Flight Procedure Tracking Form		Action: FLIGHT CHECK	Task Type: IAP	Date Open: 06/21/2018	Task #: 2014110513435101002	Request #: 20141105134351
Procedure: RNAV (GPS) RWY 11 AMDT 2			Airport ID: KSBP	Airport: SAN LUIS COUNTY RGNL		Reimbursable #: NO
City: SAN LUIS OBISPO	ST: CA	GPS #:	Estimated Chart Date: 12/05/2019		FICO #:	
Fac ID: N/A		Fac. Type:			Specialist: BRANDON MAULDIN	
Procedure Review						
	Rec'd	Rel'd	Full Name	Comments		
Lead:	04/15/2019	07/11/2019	DAVID FRESELLA			
QA:	07/11/2019					
Liaison:						
Procedure Comments:			ENROUTE	Remark Type: INFORMATION		
CONTACT MARLON ROBINSON (405) 954-3636

FIPC BASIC FORM										
PROCEDURE: RNAV (GPS) RWY 11 2			AIRPORT NAME: SAN LUIS COUNTY RGNL		AIRPORT ID: KSBP		SPECIAL CONTROL NO: SG-08-107-19			
FAC ID: KSBP11.02		CITY: SAN LUIS OBISPO			ST: CA		ORIG CHART DATE: 12/05/2019			
DFL TYPE: PROC/S	THIRD PARTY: <input type="checkbox"/> YES	EST. TIME ON SITE: 0.4	REIMB. NUMBER: AC0721		PTS TASK ID: 2014110513435101002					
PREFLIGHT NOTES										
REVIEWER:					DATE:					
COMMENTS:					CHECK ONE: <input type="checkbox"/> FLT CK REQ <input type="checkbox"/> NFCR <input type="checkbox"/> REJECT					
									YES	NO
					CPV COMP

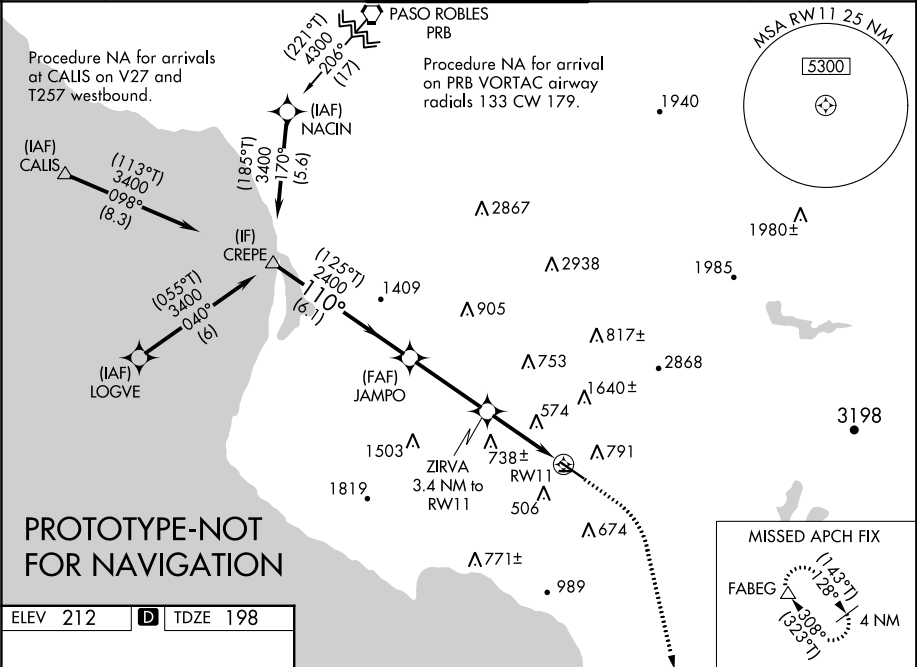
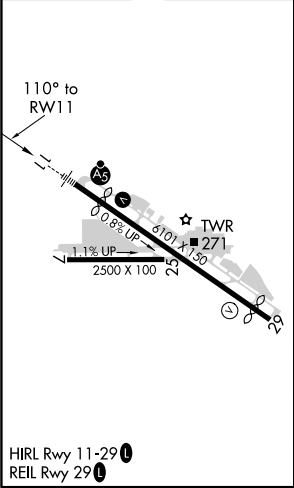
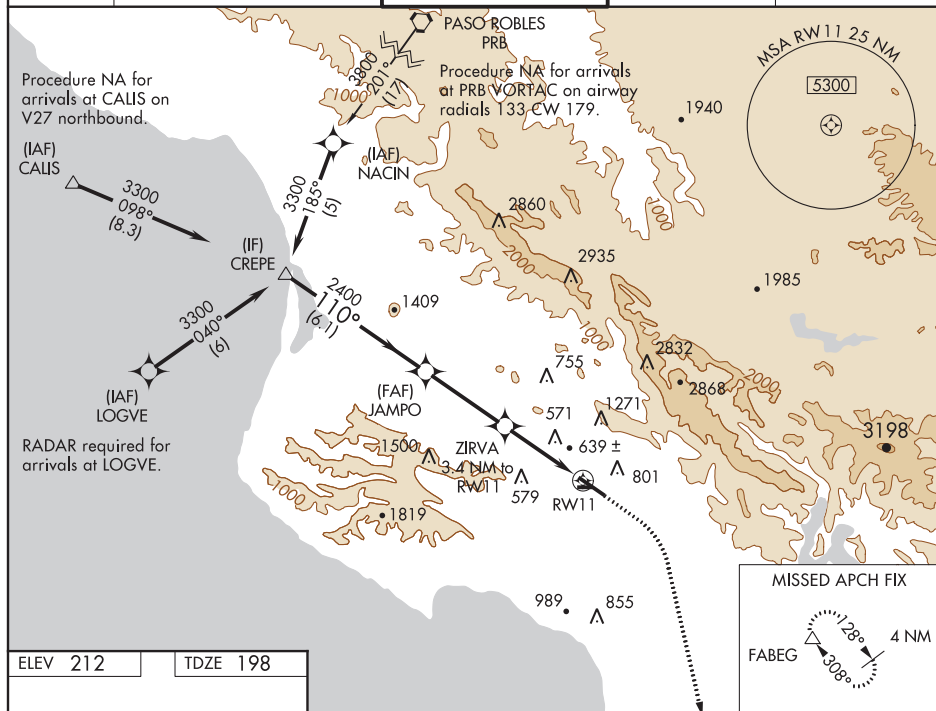
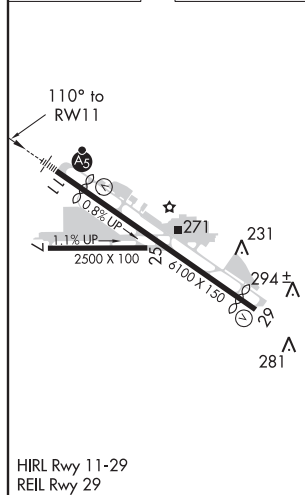
The amendments proposed for the RNAV (GPS) RWY 11 approach are to update the procedure to meet current design criteria.

RNAV (GPS) RWY 11
Move the Initial Approach Fix (IAF) NACIN 8,802.5 feet northwest. Increase crossing altitude from 3,800 feet mean sea level (MSL)/3,532 feet above ground level (AGL) to 4,300 feet MSL/3,845 feet MSL. This is a lateral move.
Increase the altitude of the segment between the IAF NACIN and the Intermediate Fix (IF) CREPE from 3,300 feet MSL to 3,400 feet MSL. Altitudes above ground level will vary along the segment. No change to ground track.
Increase the crossing altitude at the IF CREPE from 3,300 feet MSL/3,300 feet AGL to 3,400 feet MSL/3,400 feet MSL. No change to ground track.
Increase the altitude of the segments between (1) the IAF LOGVE and the IF CREPE, and (2) the IAF CALIS and the IF CREPE from 3,300 feet MSL to 3,400 feet MSL.
RNAV (GPS) RWY 29
Move the IAF FABEG 2,575 feet southeast. Increase the crossing altitude from 3,300 feet MSL/3,031 feet AGL to 3,900 feet MSL/3,787 feet AGL. Lateral move. Altitude increase

Decrease the crossing altitude at the IAF WYNNR from 4,200 feet MSL/3,218 feet AGL to 3,900 feet MSL/2,918 feet AGL.
Move the IF/IAF CADAB 1490.5 feet east-northeast. Increase the crossing altitude from 3,300 feet MSL/2,304 feet AGL to 3,900 feet MSL/2,689 feet AGL. This is a lateral move. Altitude increase.
Move the HALDA fix 342 feet northeast. Crossing altitude remains the same at 2,900 feet MSL. The altitude above ground level increases from 2,272 feet AGL to 2,347 feet AGL. This is a lateral move. Crossing altitude does not change.
Move the Final Approach Fix (FAF) CAVLI 221.4 feet southeast along its existing track to become the new Precision FAF. Crossing altitude remains the same at 2,400 feet MSL. The altitude above ground level increases from 2,050 feet AGL to 2,058 feet AGL. Move is along the existing track. No lateral move.
Add a new Step Down Fix 1.8 nautical miles (NM) northwest of the PFAF; i.e., between the PFAF and the RWY

Amend the Missed Approach.
Add Localizer Performance with Vertical Guidance line of minimum.
